**COMMUNITY DEVELOPMENT DEPARTMENT
PLANNING DIVISION
STAFF REPORT**

TO: Design Review Board
FROM: Planning Staff – Jeremy Hammar, Senior Planner
DATE: January 23, 2025

RE: Gig Harbor Fire & Medic One, Station 51 (PL-DR-24-0017)
Public Meeting Date: January 23, 2025

1 ELECTRICAL SITE PLAN
SCALE: 1"=20'-0"

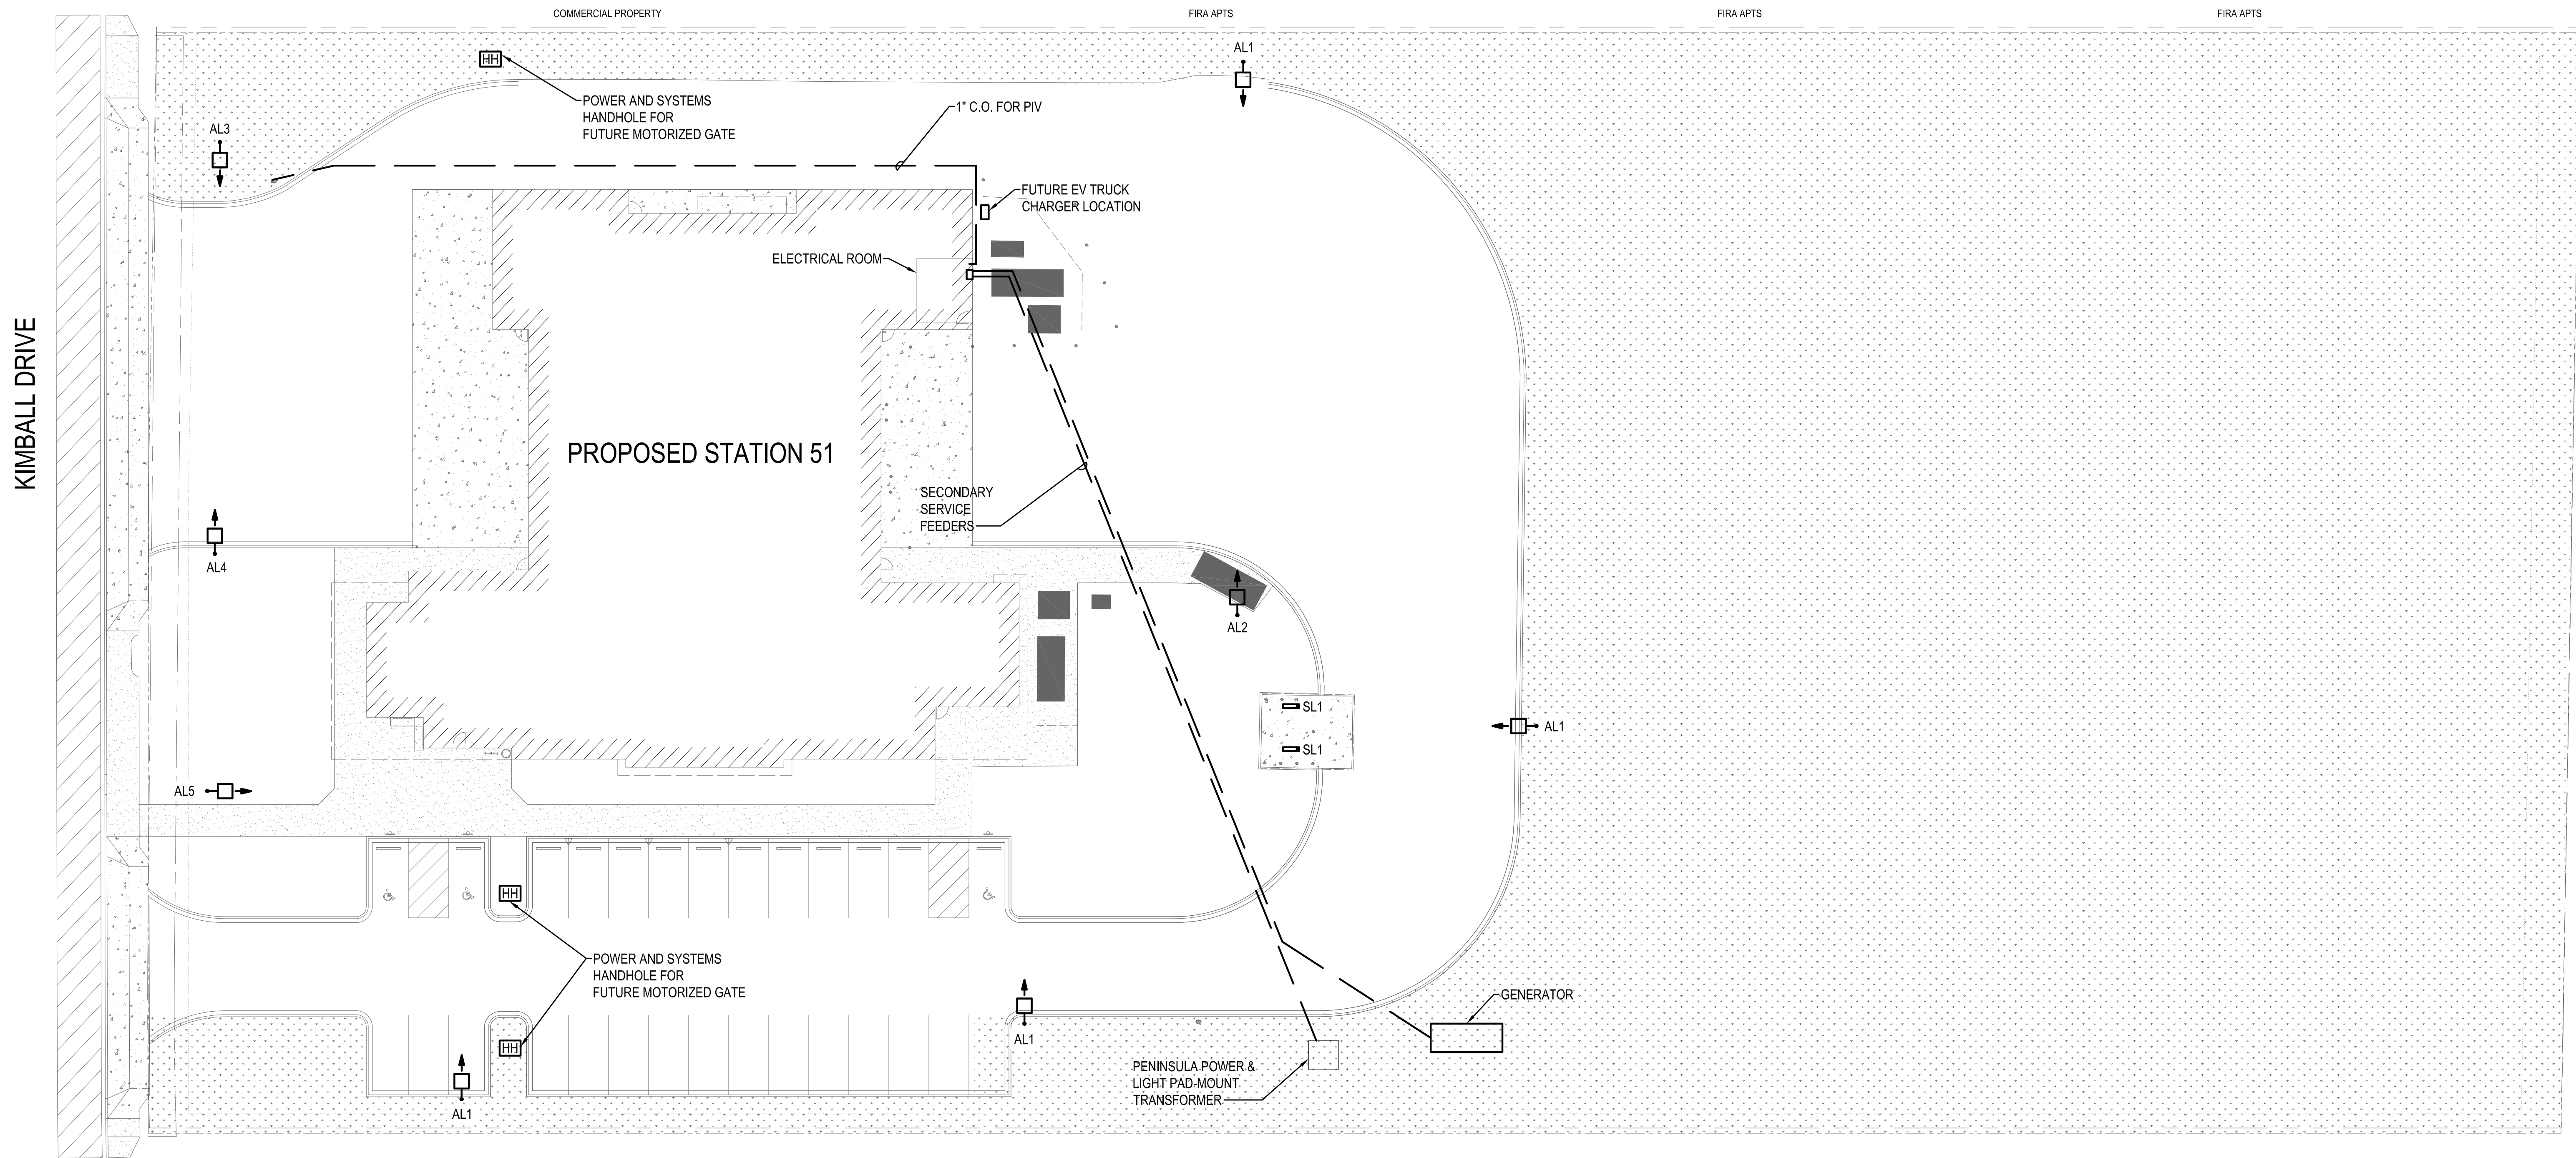
An existing light pole is located within the buffer area, northeast of the building adjacent to an on-site fire hydrant. The light pole has a cutoff luminary head, directing light to the interior of the site and away from the property line. This condition will be upheld under re-development. There are also three exterior wall mounted LEDs planned along the north face of the proposed building. These are similarly designed to direct light downward toward the site interior and away from the property line. Please refer to the attached Electrical Site Plan and Lighting Calculations.
